**RE: DVN-67391 - ADMINISTRATIVE DEVIATION
ADMINISTRATIVE CYCLE – NOVEMBER 2016**

The applicant is requesting an Administrative Deviation to allow a rear yard setback of 28.48 feet where 30 feet is required at 4017 Turquoise Falls Street.

GRAND CANYON & ALEXANDER LOT 8 SITE PLAN

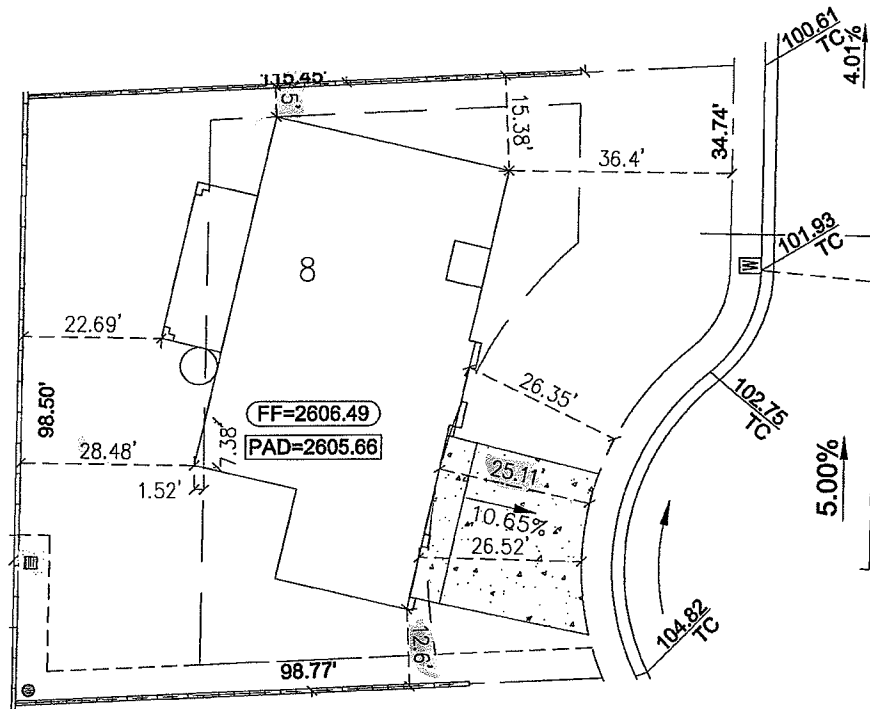
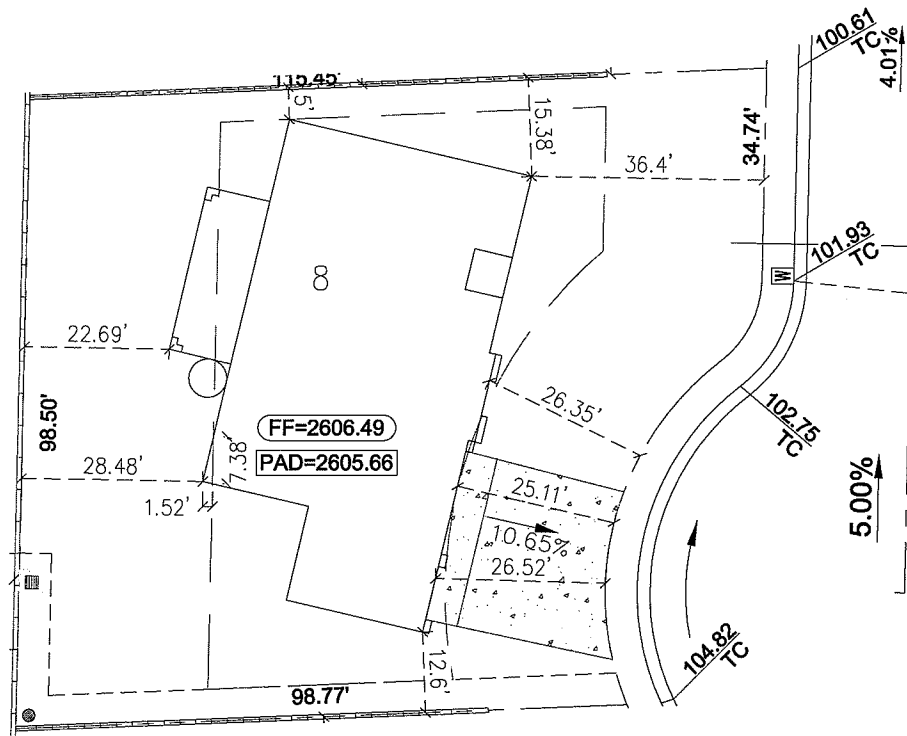
The subject property is located within an R-D (Single Family Residential-Restricted) Zoning District. The property is subject to Title 19.06.065 Development Standards for building placement. The applicant's request represents less than a 5% deviation to the setback and extends less than 15 feet parallel to the property line from which the setback is measured, per Title 19.16.120 meeting the minimum requirements for consideration as an Administrative Deviation.

The request represents less than 10% of the required setback, meeting the minimum requirements for consideration for an Administrative Deviation. The Department of Planning approves the request, as it is minor in nature and will not negatively impact the adjacent residential properties. The Department of Planning administratively approves this request.

Lot 8: the rear building setback is required to be 30'. At the south westerly corner of the proposed building, we are at 28.48'. We would like to ask for an administrative deviation of the rear setback of 1.52' since we are only encroaching for 7.38' of the entire building width.

The Department of Planning has administratively **APPROVED** a request for an Administrative Deviation TO ALLOW A REAR YARD SETBACK OF 28.48 FEET WHERE 30 FEET IS REQUIRED on 0.24 acres at 4017 Turquoise Falls Street (APN 138-06-413-008), R-D (Single Family Residential-Restricted) Zone, Ward 4 (Anthony), has been considered administratively by the Department of Planning staff.
